Access Compliance Report Public Rights-of-Way (Curb Ramps)

Main Street: LA_SALLE_LN		Cross Street: COUSTEAU_LN		Location:	NE
ADA ID: RPRK211110135517	Ramp Type: Type 4 - Parallel	Initial Pass/Fail: Fail	Overall Compliance: No	Severity Score:	15
Codes/Mitigation Info/Possible Solution			Field Measurements/Component Compliance

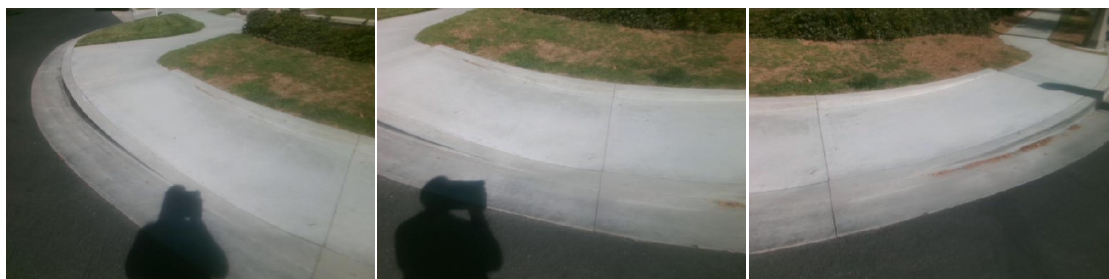
R204.3, R304.3.2, STD 1115

Remove & Replace Curb Ramp With Two New Directional Ramps or Equivalent.
